## RAI 2-1

### AREVA Response

Figure: Compressive Stress-Volumetric Crush of Hemlock Wood

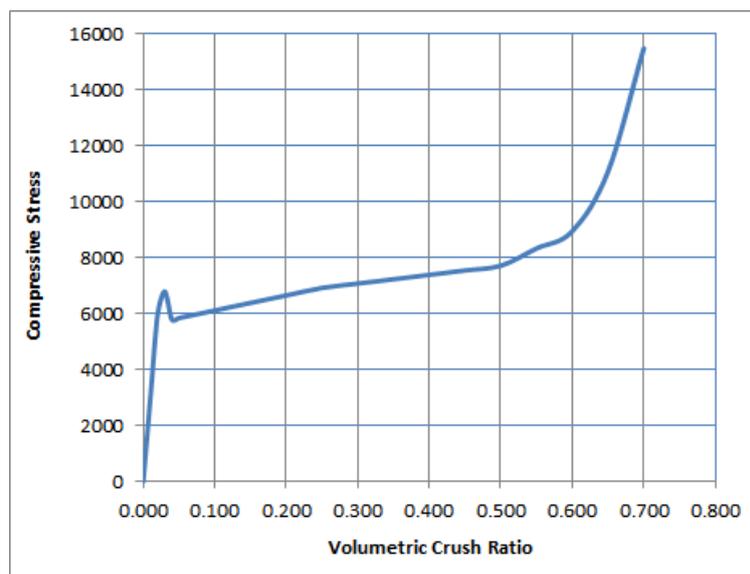
The staff asked the applicant to better explain the conservatisms assumed in the end drop analysis and to provide additional details about the assumptions used to model the block and the unyielding surface (e.g., material). The applicant indicated that it provided the material's properties in the report. The applicant also indicated that it performed a finite element analysis with the material properties. The staff asked the applicant to provide a summary of its finite element analysis using the LSDYNA code and explain modeling assumptions as well as results. As the RAI requested, the response should include both qualitative and quantitative descriptions of the end drop analysis, the damage experience of the package (including the fuel), and explanations of how the analysis meets the regulations in 10 CFR Part 71.

Developed from the above material model and the characteristics of observed actual wood sample test result of the above references, the applied compressive stress-volumetric crush for the axial compression of lumber is obtained and presented in the figure below. The sloped feature of the curve is implemented to improve the numerical stability of the LSDYNA program runs.

This material model has an average compressive stress of 7200 psi that matches the data in Appendix A.5 of Reference 2-1-1. For the cold temperature application, the stiffness of the wood is conservatively increased by 14%. This material is modeled as crushable foam in the LSDYNA program.
